Delegated Report

Planning & Listed Building Consent Applications

Planning Application No: 20231032
20231033

Location: Gravesend Delivery Office, 144 Milton Road Gravesend Kent

Proposed Roof Plan

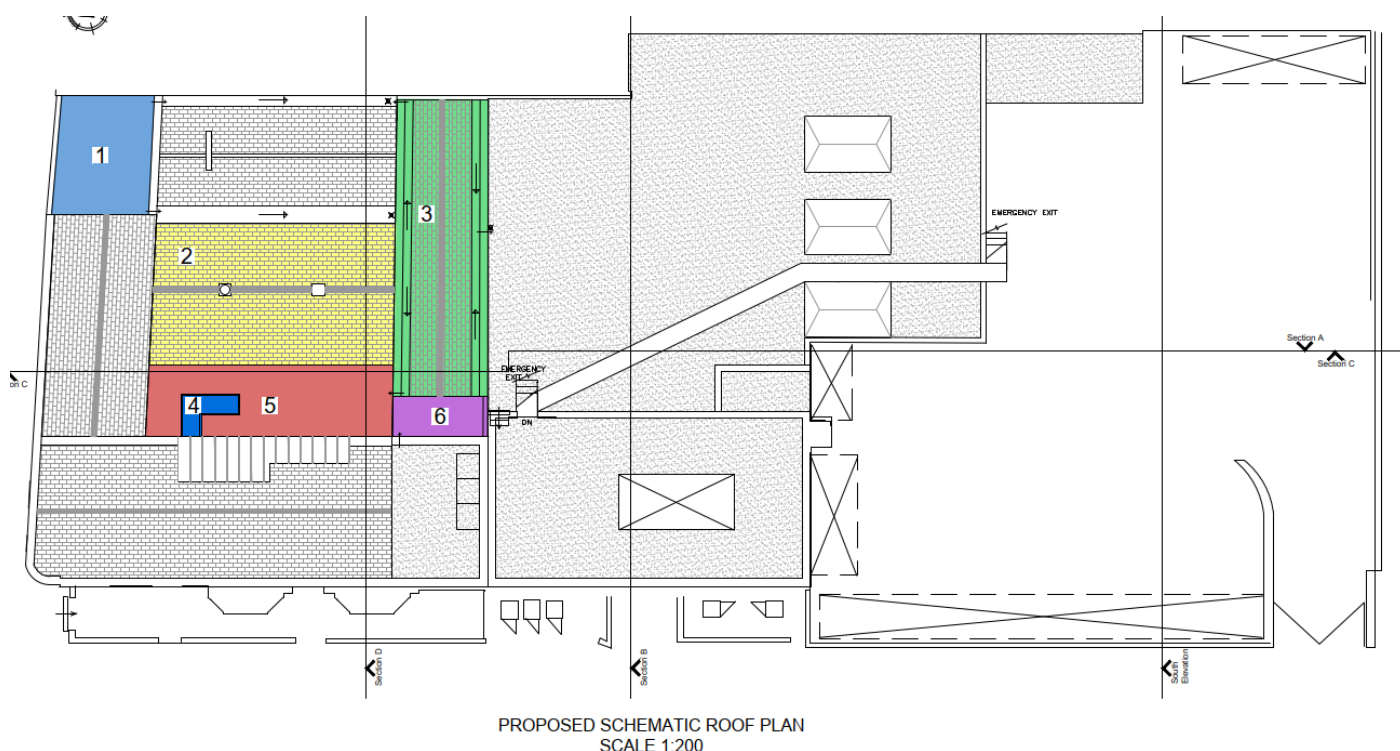
Roof 1: Supply and install a liquid roof coating to the entire roof – This is considered a sympathetic method and acceptable as it will provide a Waterproofing System to the roof which will help prevent any future water ingress which is a benefit for the building.

Roof 2: Remove existing sloped glazed rooflight, infill the structural opening with roof construction to match and supply and install new felt, battens and grey Welsh slate tiles to match – The rooflights are in a more modern addition to the building and their removal would not therefore have any impact on the significance of the main original 1850 part of this listed building which is the highest significance. Welsh slates are proposed for the infilled roof which are highly appropriate for this listed building; a condition would be required for a sample of the Welsh slate to ensure its suitability should permission be forthcoming.

Roof 3: Remove all the existing slate tiles to the entire roof slope and supply and install new felt, battens and grey Welsh slate tiles to match existing. This part of the roof is a more modern addition to the building and not the original c. 1850 part, the replacement of the existing roof would therefore be acceptable. Welsh slates are proposed which are highly sympathetic. This proposal would therefore not have any harmful impact on the significance of this grade II listed building subject to a sample of the slate.

Roof 4: Remove the existing flat roof covering and external wall cladding and recover the flat roof with a new insulated roof system as per the submitted details; supply and install new external insulated wall cladding to match the existing. The existing flat roof element is a modern and an incongruous addition, the removal of its existing roof covering and replacement with an insulated roof covering to match existing therefore raises no issues.

Roof 5: Remove the existing glazed roof lantern; infill the structural opening with flat roof construction to match the existing: supply and install a new insulated roof system to the entire roof area, creating an upstand where rooflights has been removed. This is the roof of a more modern addition to the building and the removal of the roof lantern and replacement with a flat roof therefore raises no issues in terms of the significance of the listed building as it does not relate to the original 1850 part of the building. The flat roof relates to an 'inner' part of the roof of the building and would not be visible from any public realm due to being a lower height than the main three storey part of the building fronting Milton Road and The Grove.

Roof 6: Supply and install a liquid roof coating to the entire roof area as shown in the submitted details – As for roof 1 this is considered a sympathetic method and acceptable as it will provide a Waterproofing System to the roof which will provide a Waterproofing System to the roof which will help prevent any future water ingress which is a benefit for the building.
